Display

Subject: **NO POWER-ON**

Model: **BVM-14E1U, BVM-14E5U, BVM-14F1U, BVM-14F5U, BVM-14G1A, BVM-14G1E, BVM-14G1U, BVM-14G5A, BVM-14G5E, BVM-14G5U, BVM-20E1U, BVM-20F1U, BVM-20G1A, BVM-20G1E, BVM-20G1U**

Figure 1

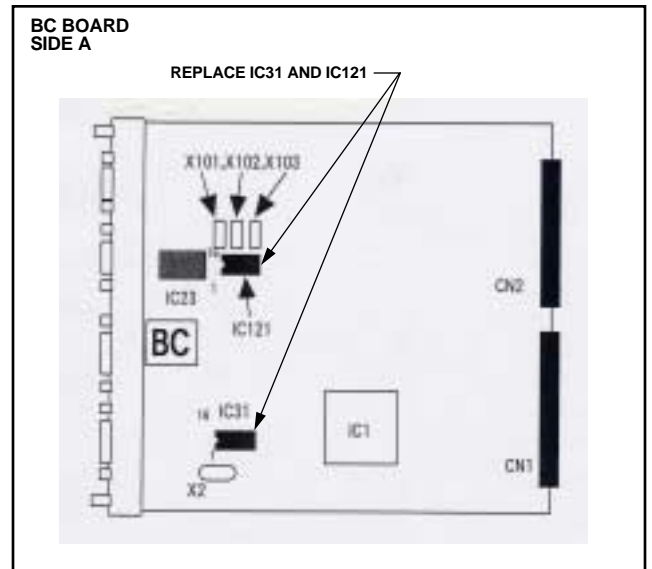
BC Board (See Figure 1.)

1. Replace IC31 (TC74VHCU04) with a new IC.
2. Replace IC121 (TC74VHCU04) with a new IC.

Part No.	Description	Qty.
8-759-460-38	IC MC74HCU04AF	2
